**GEOTECHNICAL AND GEOLOGIC HAZARD INVESTIGATION**  
**The Ridge Nests Development**  
**Powder Mountain Resort**  
**Weber and Cache Counties, Utah**

IGES Project No. 01628-008

July 15, 2016

Subject: Response to Review Comments  
Geotechnical Investigation  
The Ridge Nests Development  
Powder Mountain Resort  
Weber and Cache Counties, Utah

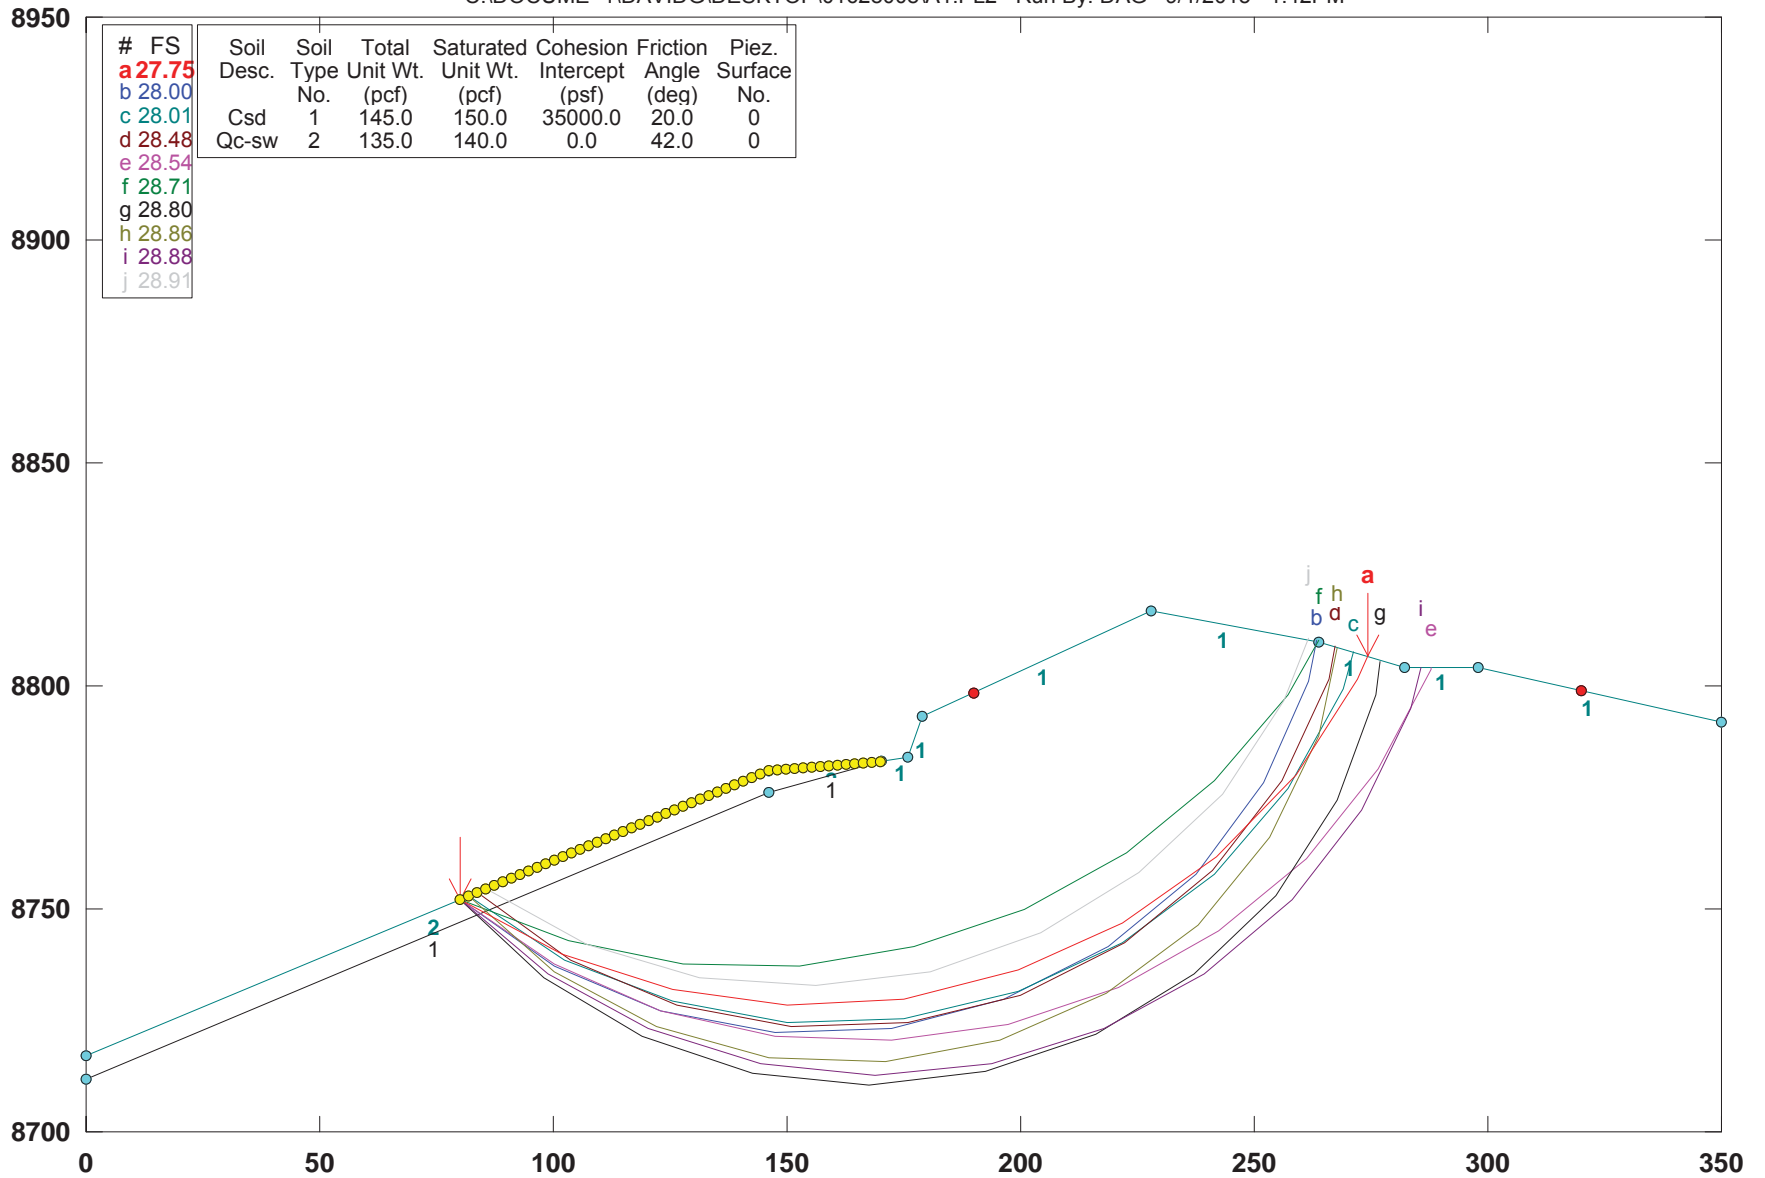
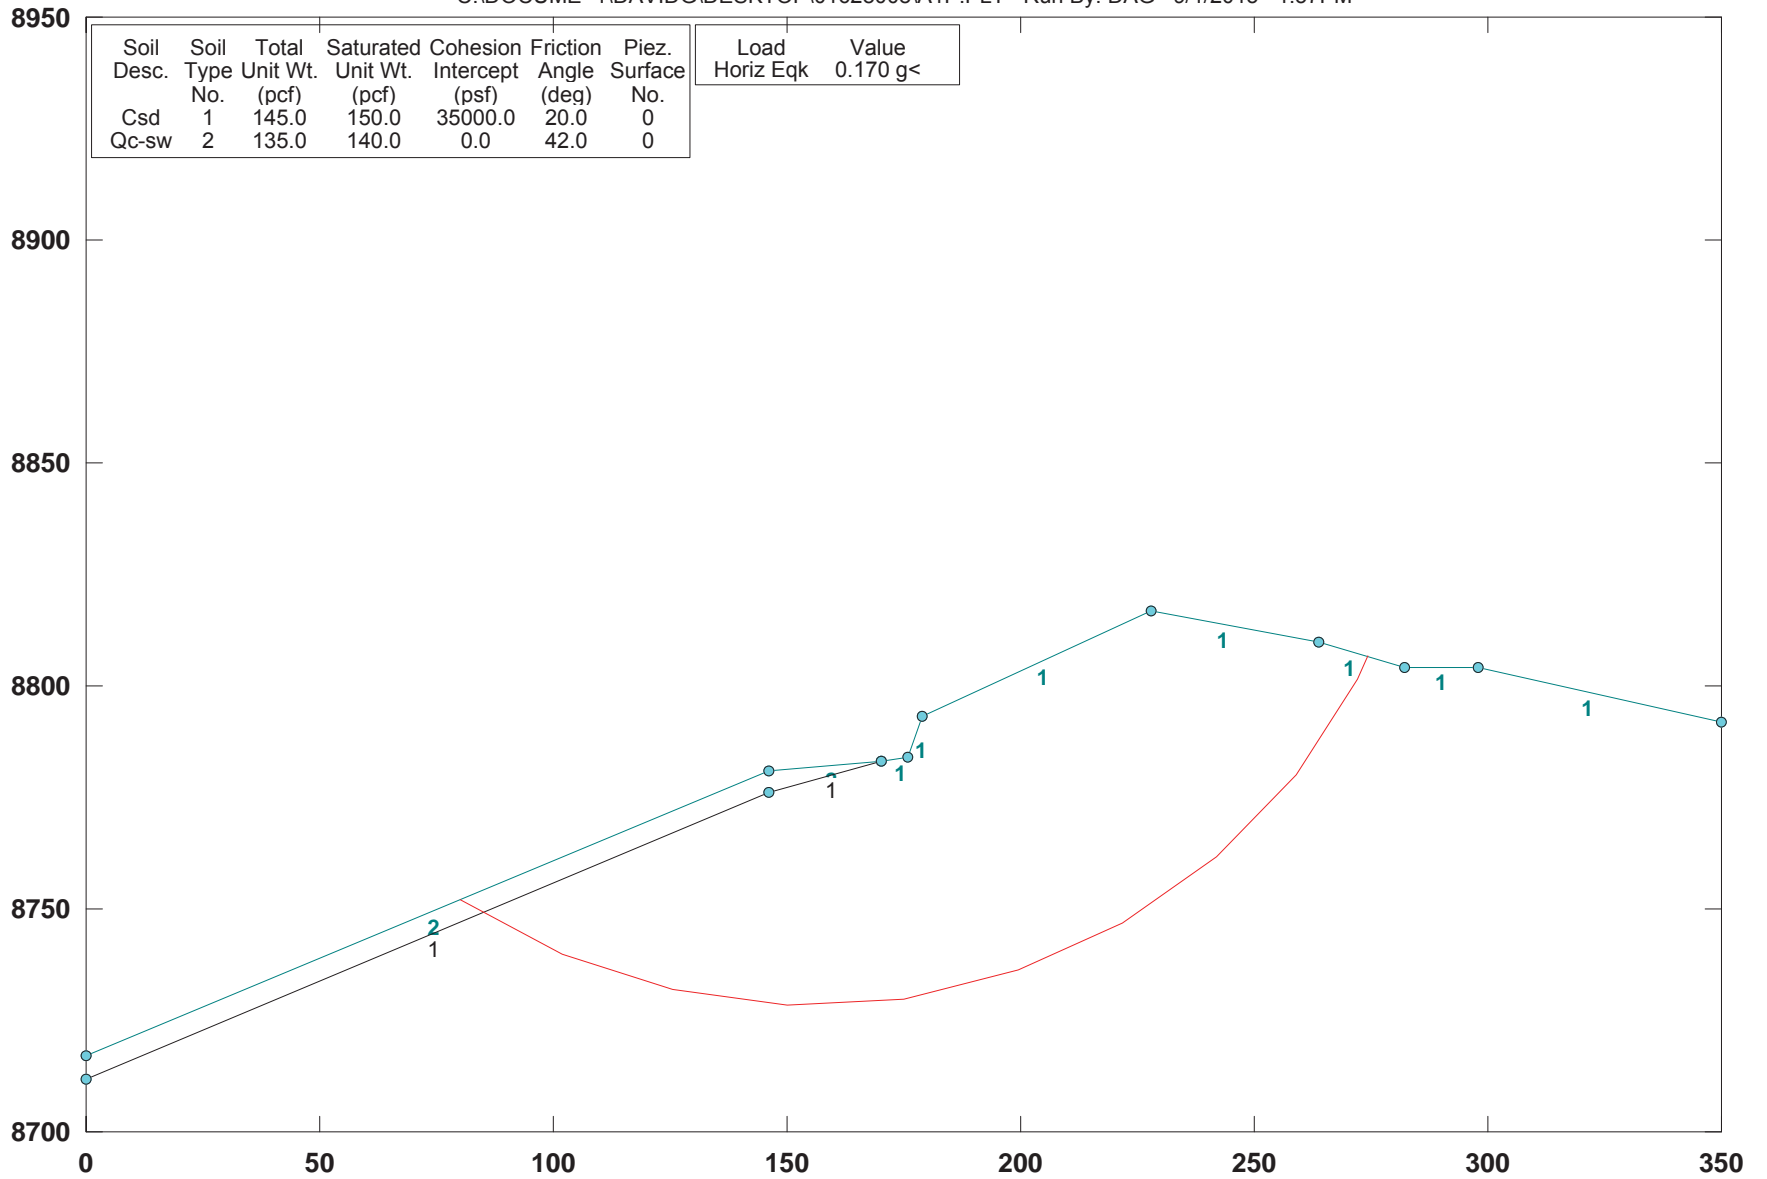
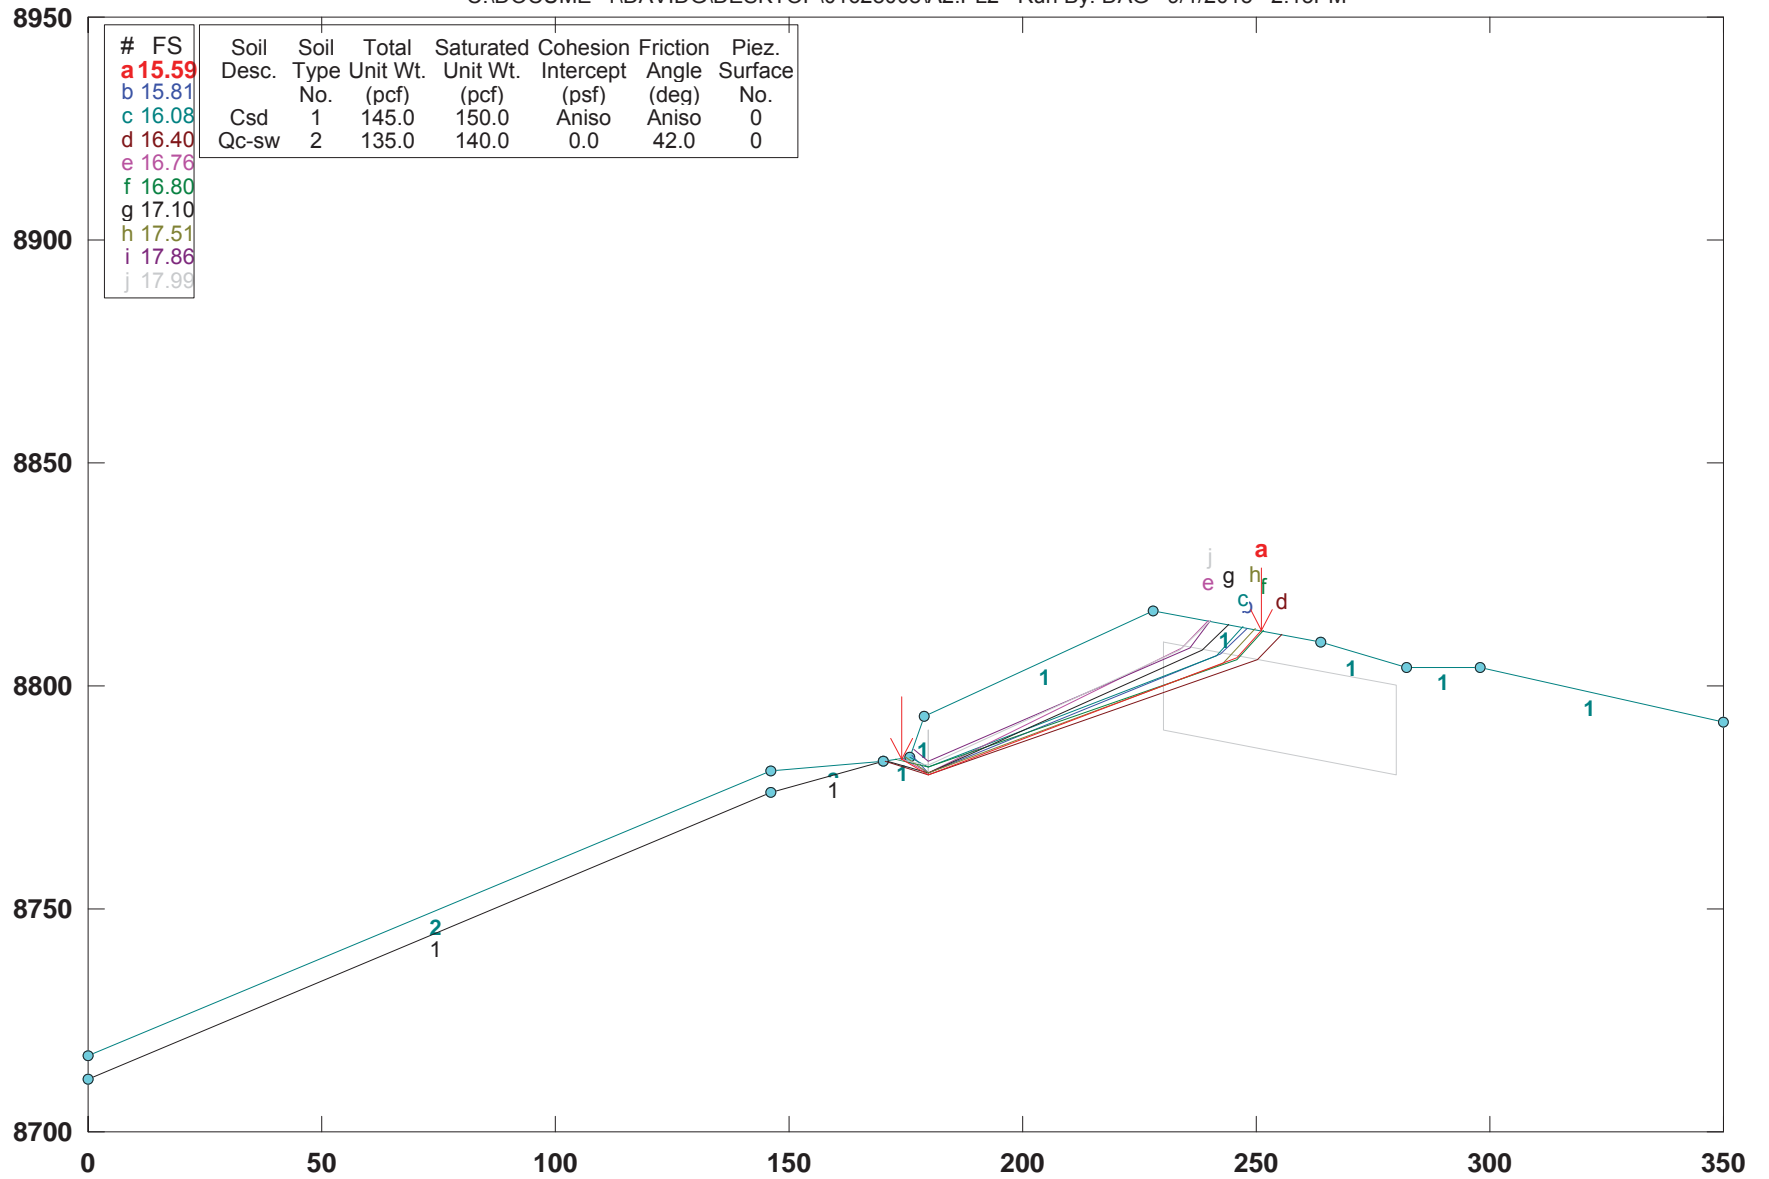
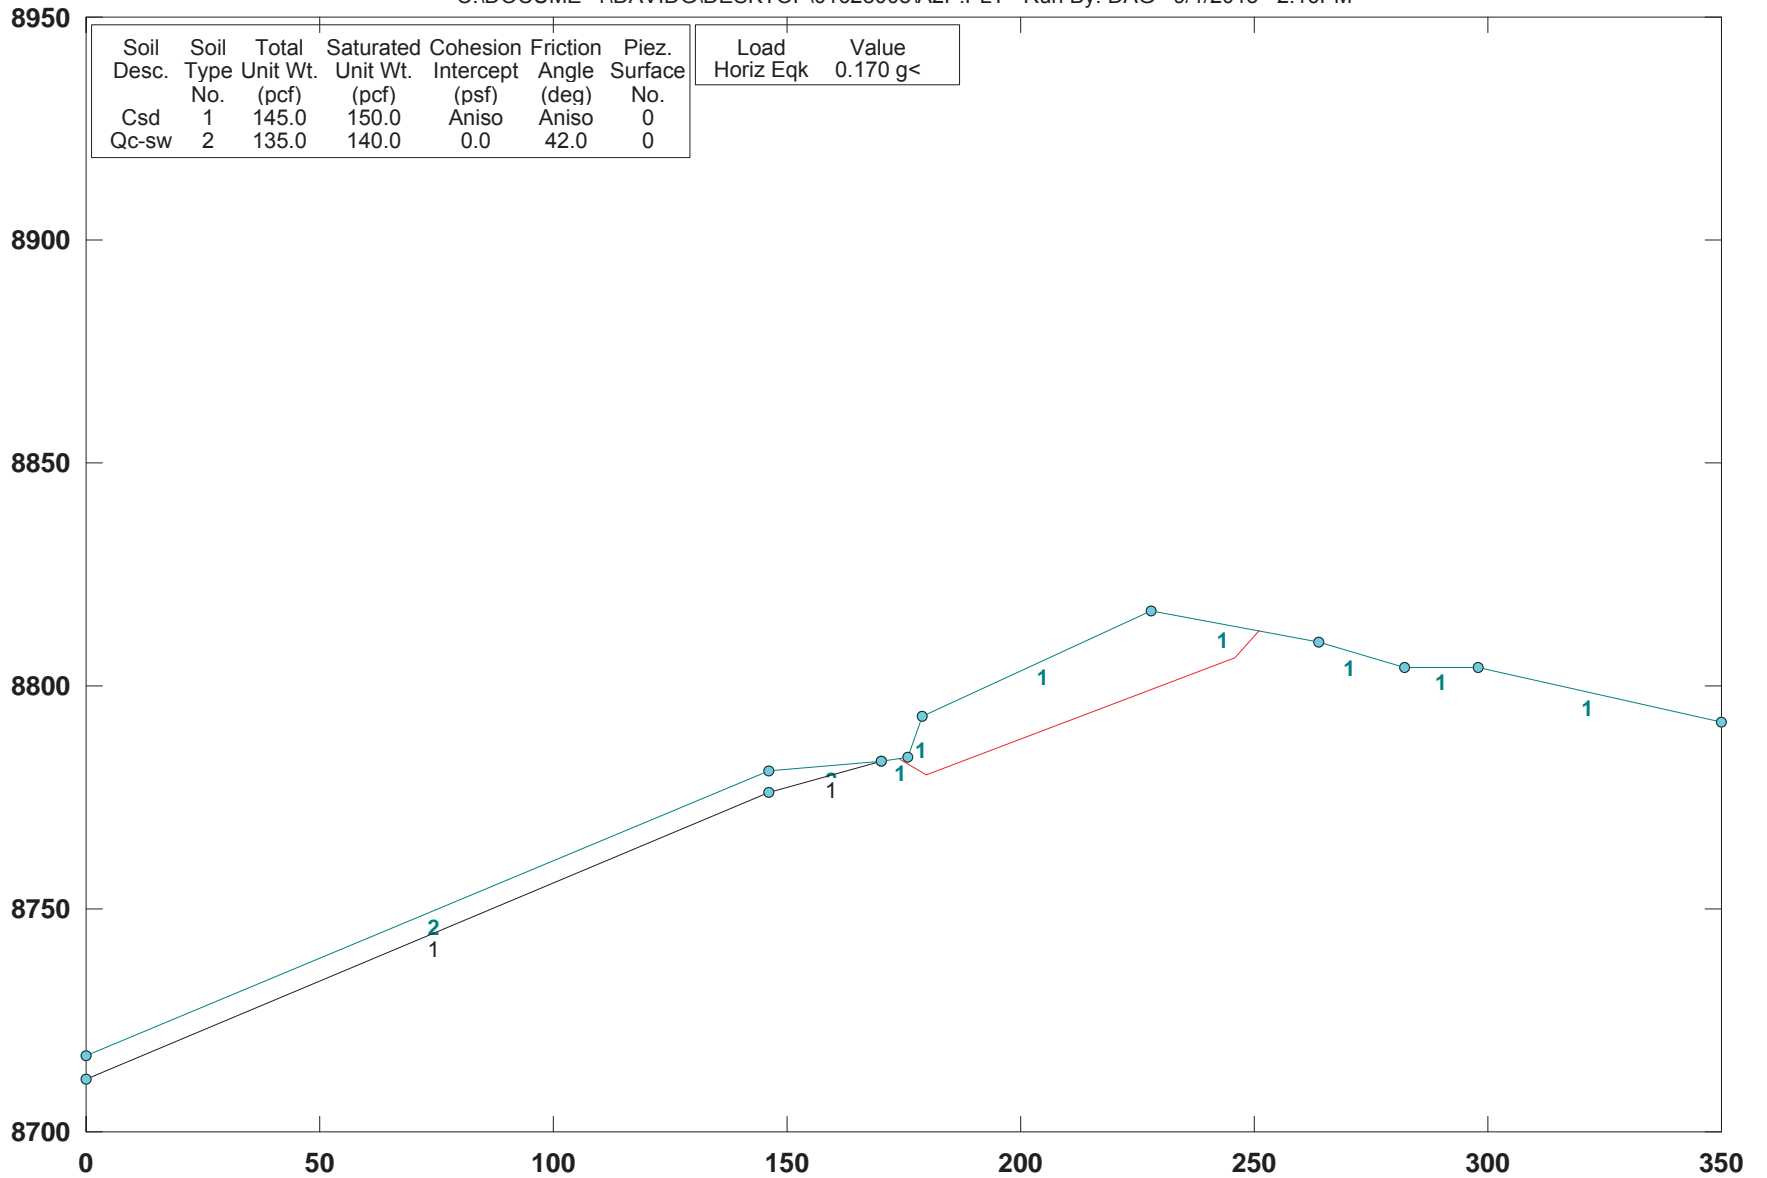
#### **Comment No. 1**

The global stability of the slope was modeled using gSTABL7 slope stability software. Bishop’s Method and Janbu’s Simplified method was used to model the slope, as appropriate. For our analysis, we have assessed two representative sections, Section A-A’ and Section B-B’, illustrated on Plate 1 (*Geologic Map*) and the *Geologic Cross-Sections*, Figure 1, attached. Calculations for stability were developed by searching for the minimum factor-of-safety for both a circular-type failure and a block-type (translational) failure. For the circular analysis model, arcuate failure surfaces and homogenous earth materials were assumed. For the block analysis, anisotropic strength parameters in the bedrock was assumed, based on the apparent dip of bedding. A minimum static factor-of-safety of 1.5 and seismic factor-of-safety of 1.0 (global stability) was considered acceptable for this project considering the available information and design assumptions.
